BID ADDENDUM NO. 1
TO
CONTRACT DOCUMENTS
AND
TECHNICAL SPECIFICATIONS
FOR
POOL LOCKER ROOM RENOVATIONS
AT
HOMMOCKS MIDDLE SCHOOL
NYSED #66-07-01-03-0-011-031

Mamaroneck Union Free School District
1000 West Boston Post Road
Mamaroneck, NY 10543

LAN Job #4.1092.87
September 13, 2024

6
A7.02
3/8" = 1'-0"
MEN'S BATHROOM

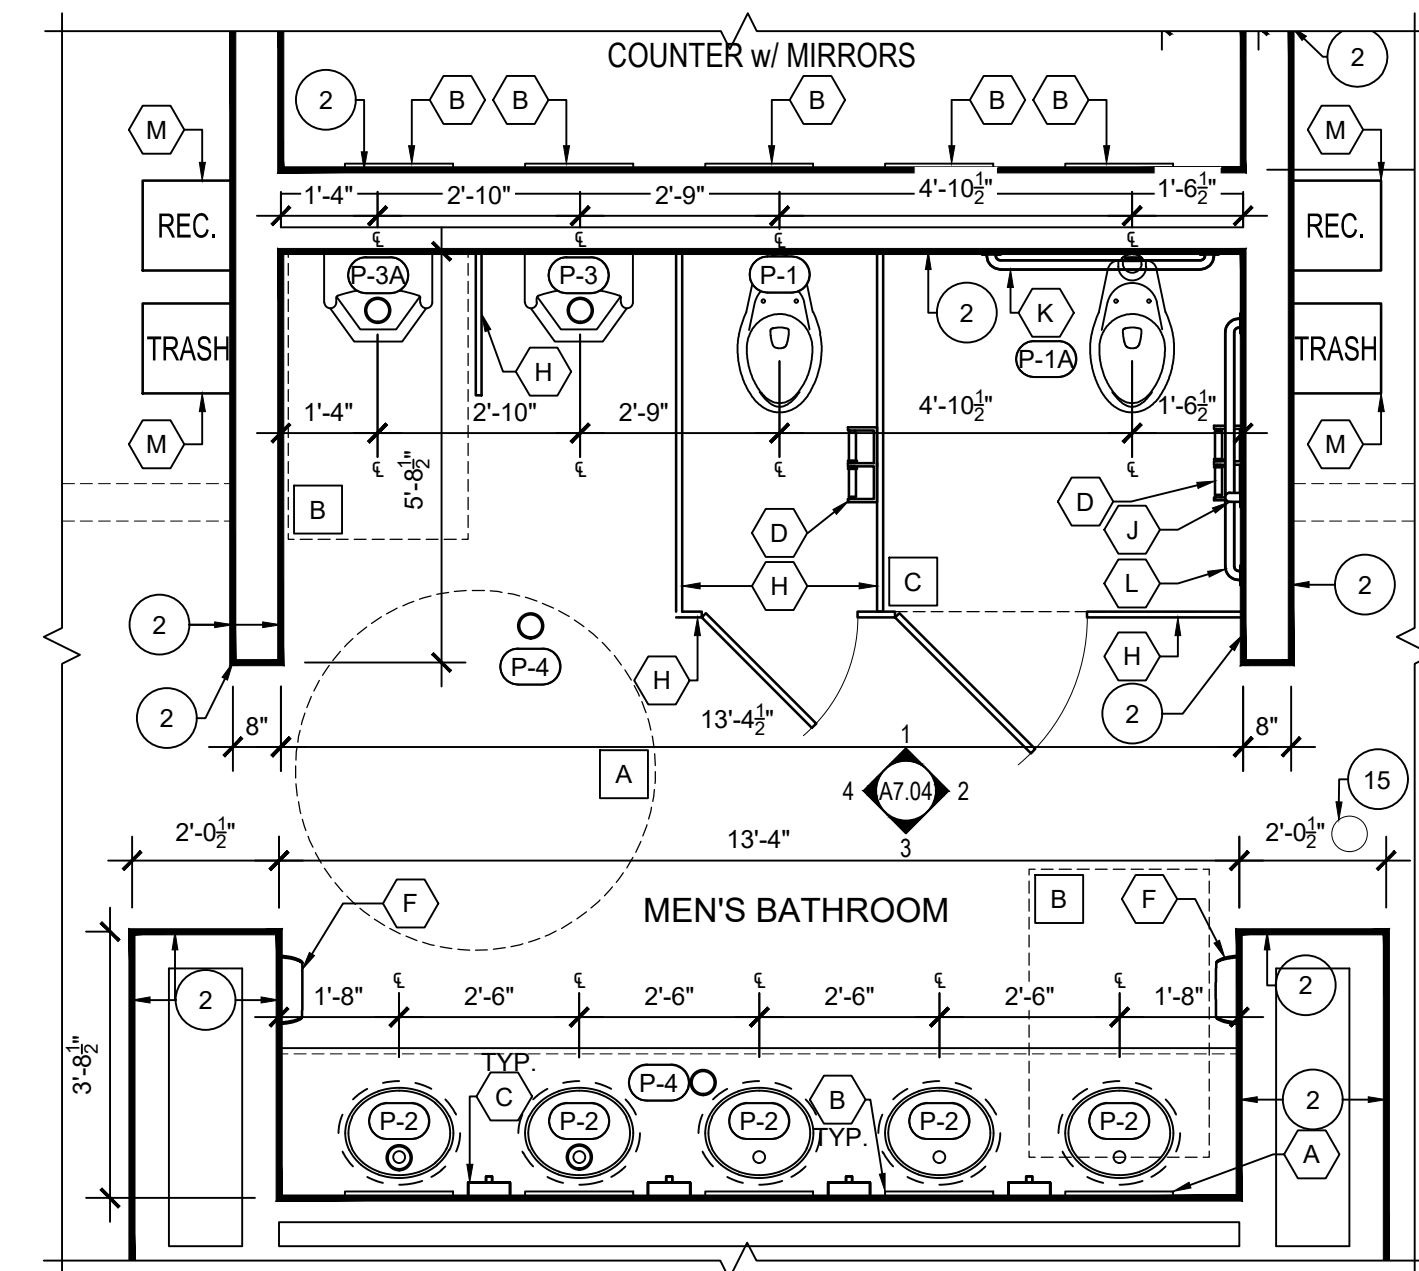
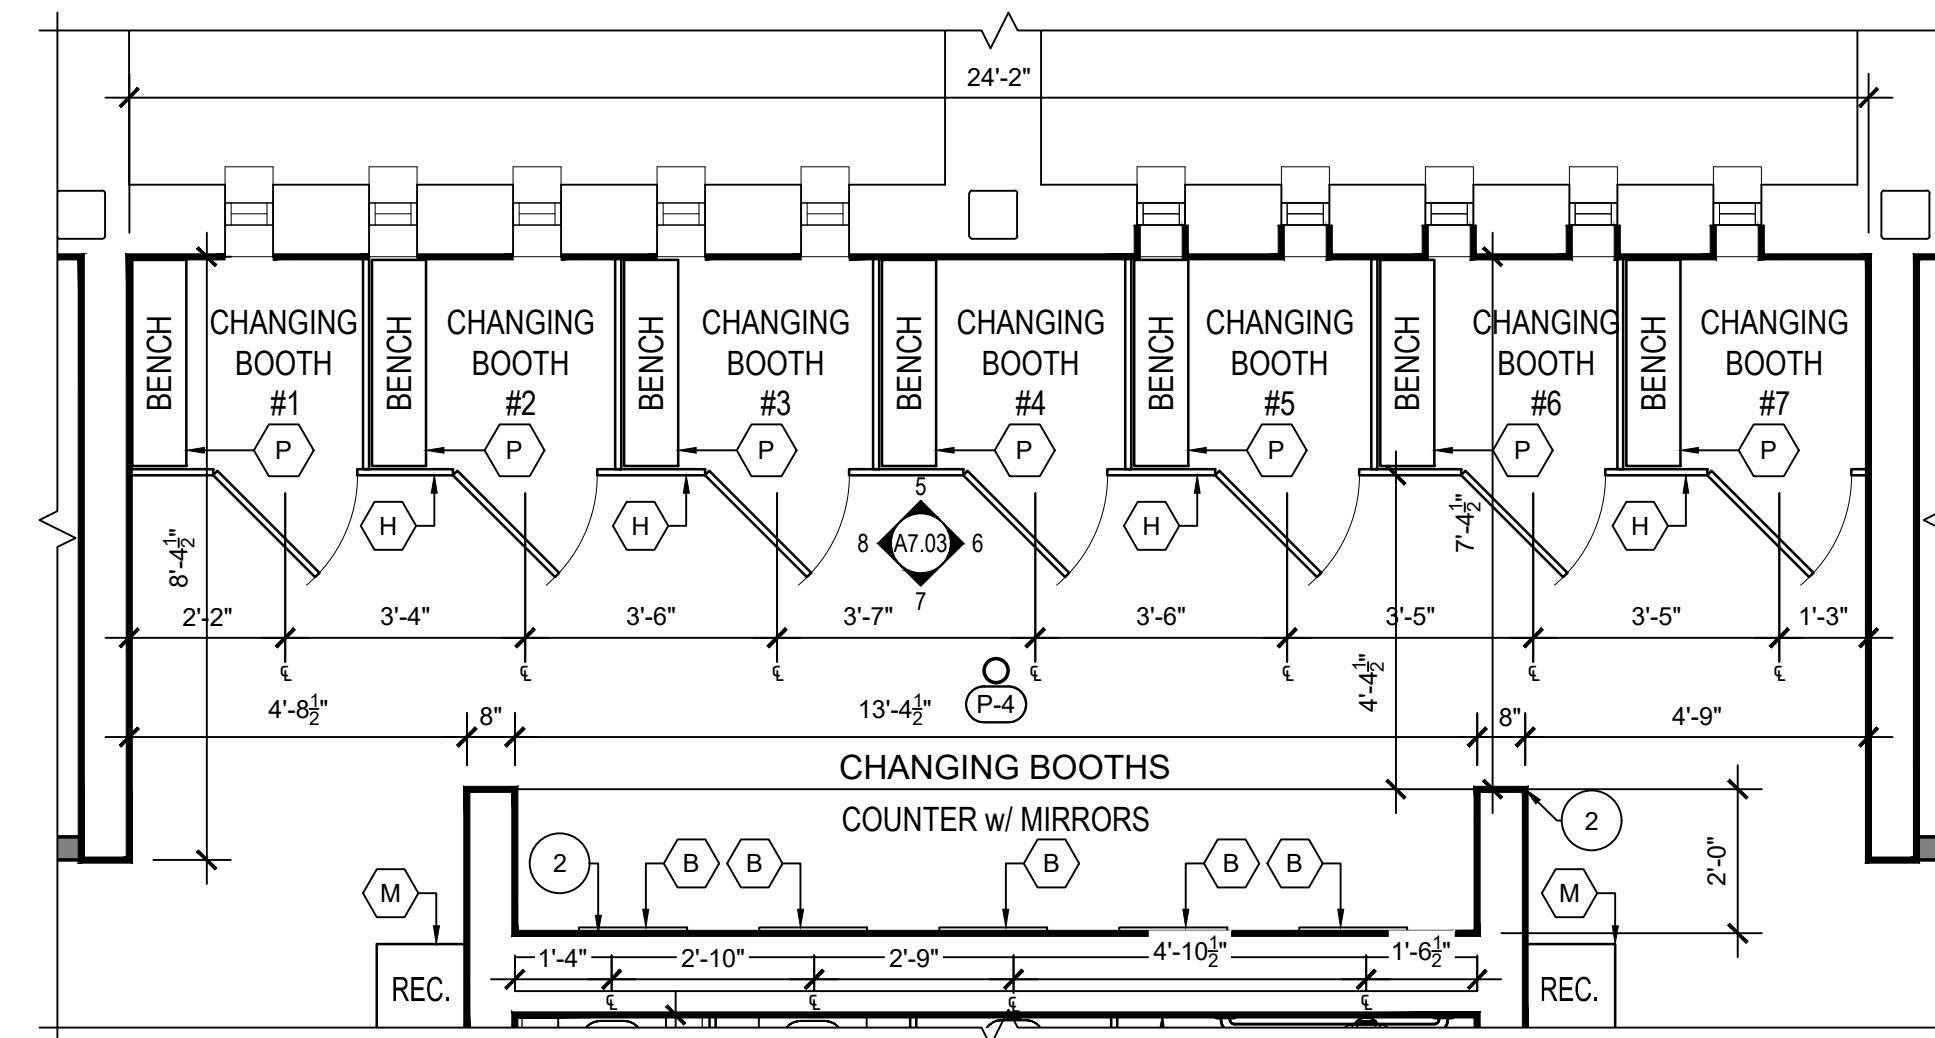
A7.02	<p><u>Drawing A7.02:</u> The following doors have been revised to be replaced with new: the corridor door accessing the men's locker room, the storage room door in the men's locker room, and the closet doors in the ADA/Family/Gender Neutral Changing Room 115 and Family/Gender Neutral Changing Room 131.</p> <p><u>Drawing A7.02:</u> The revision includes changes to the plumbing fixture tags for the new shower pans.</p>

ELECTRICAL PROPOSED PLAN

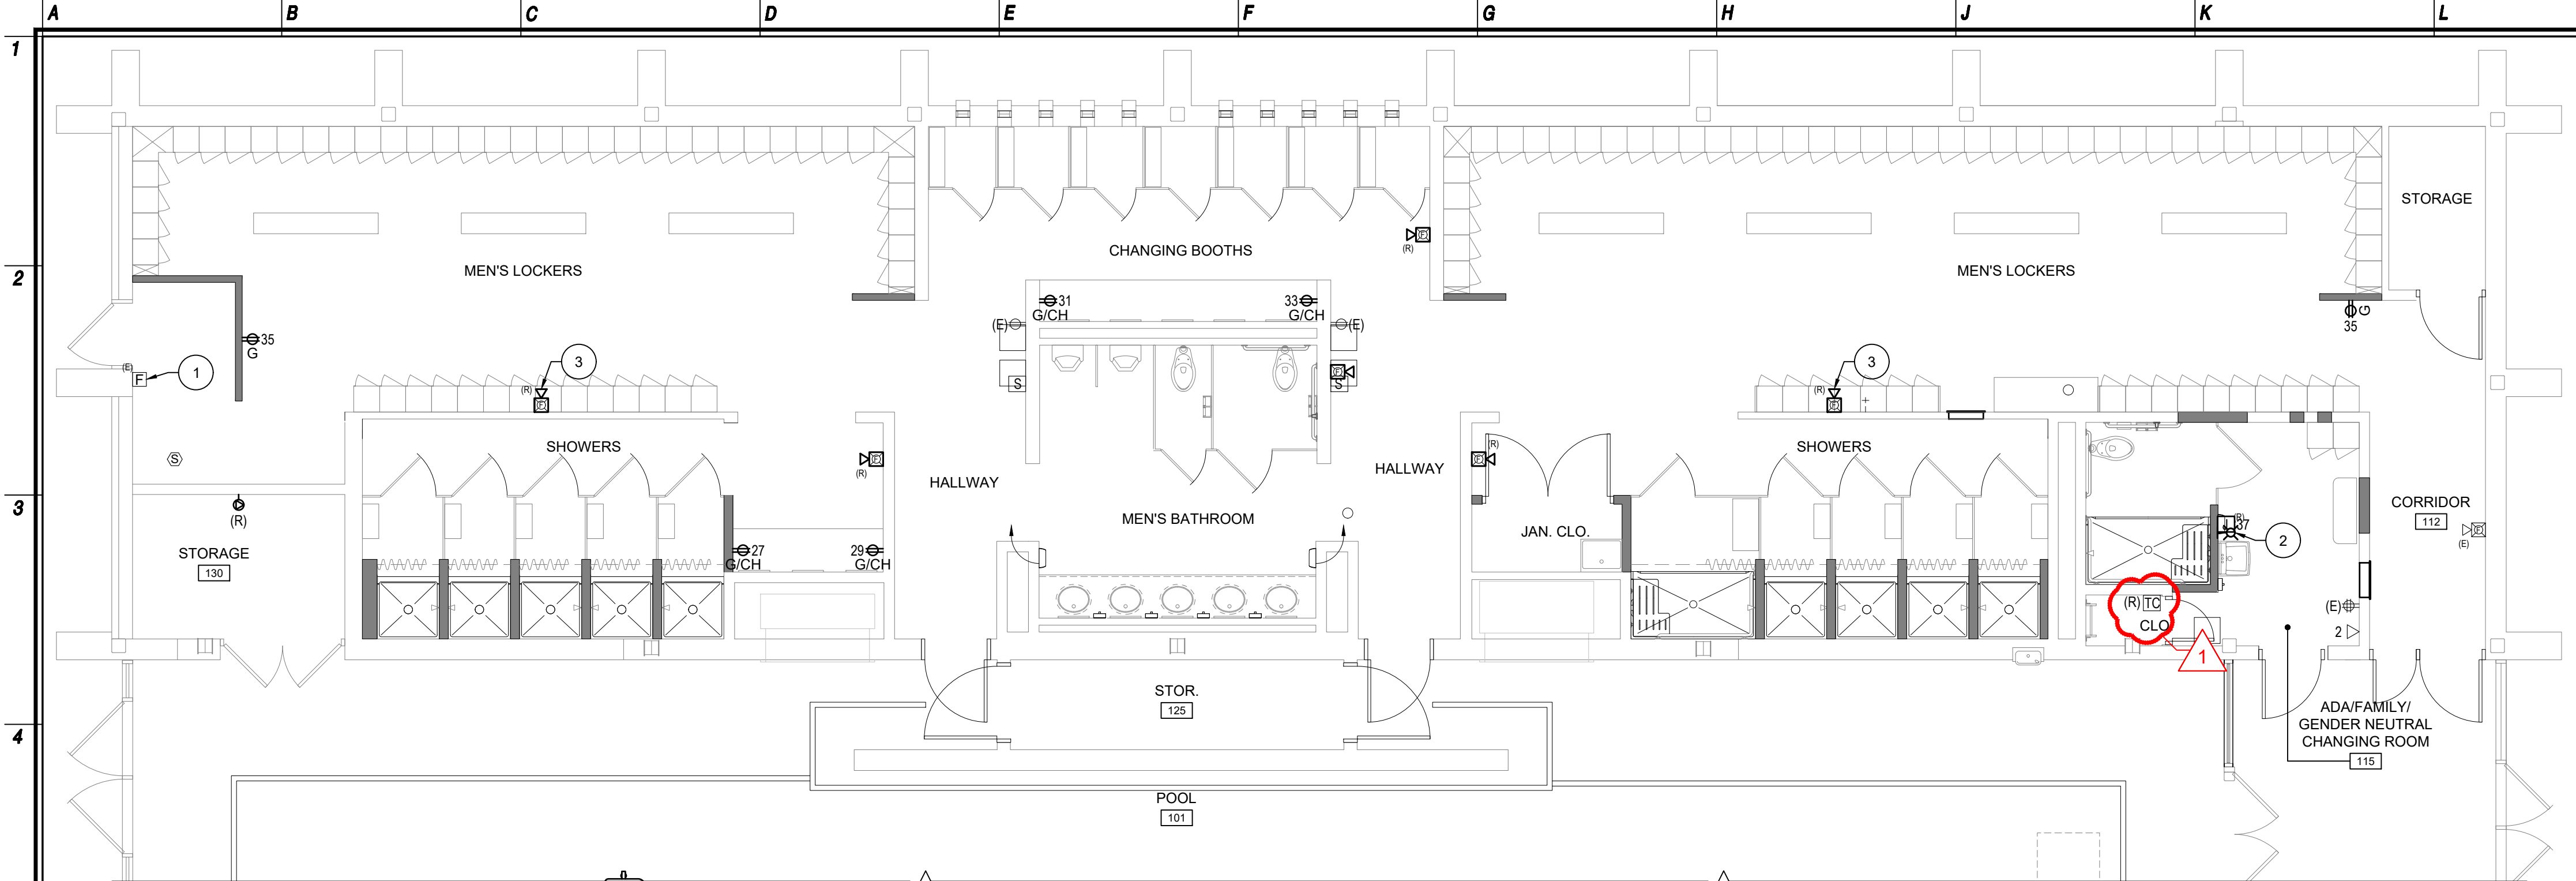
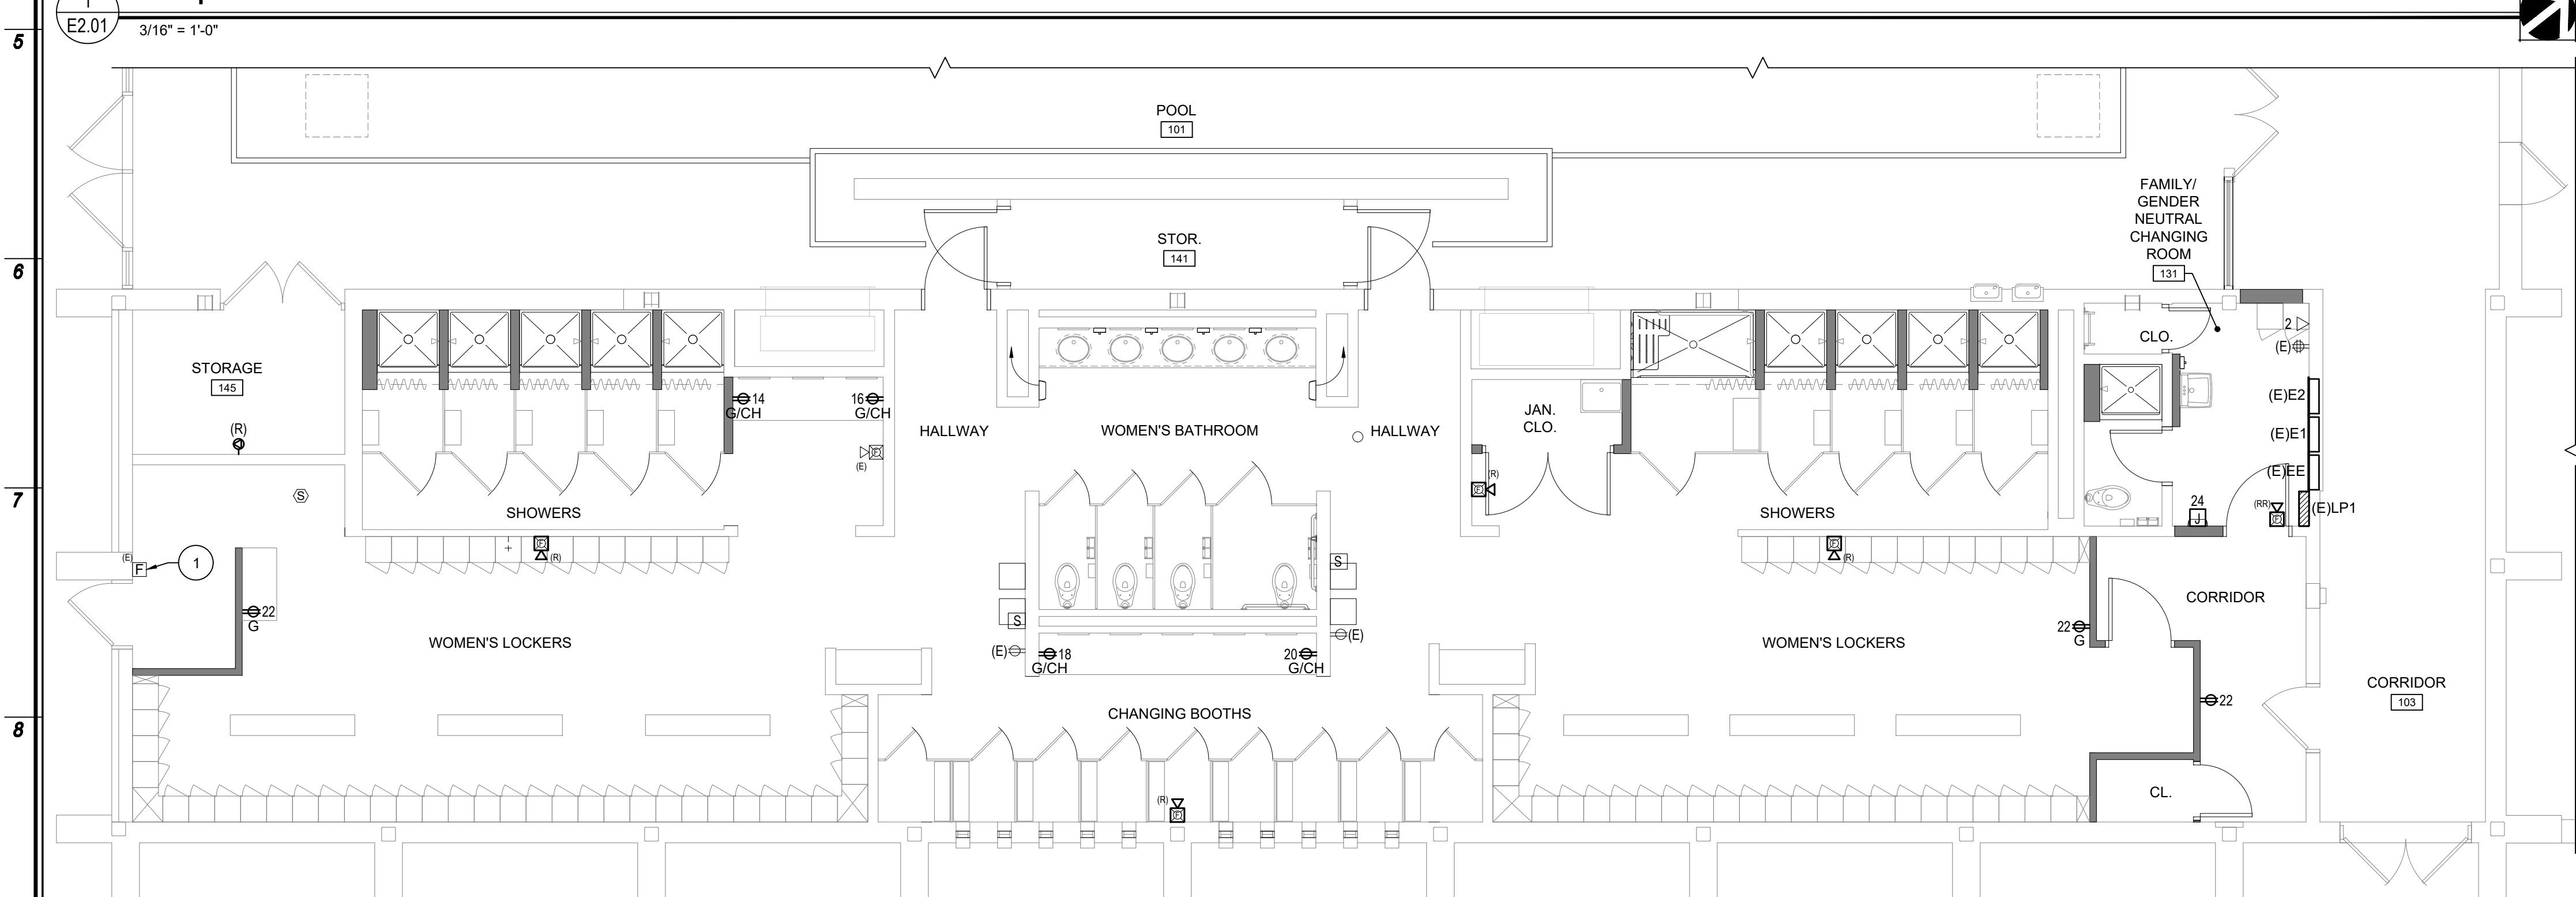
- Response: Provided and installed by the GC. Wired by the EC.
- 12 Comment: Please advise the finish plates we are to use in each Locker Room; are we to use standard plastic plates or WP in-use plates?

- Response: Refer to revised drawing E2.01. All new wall plates shall be stainless steel.
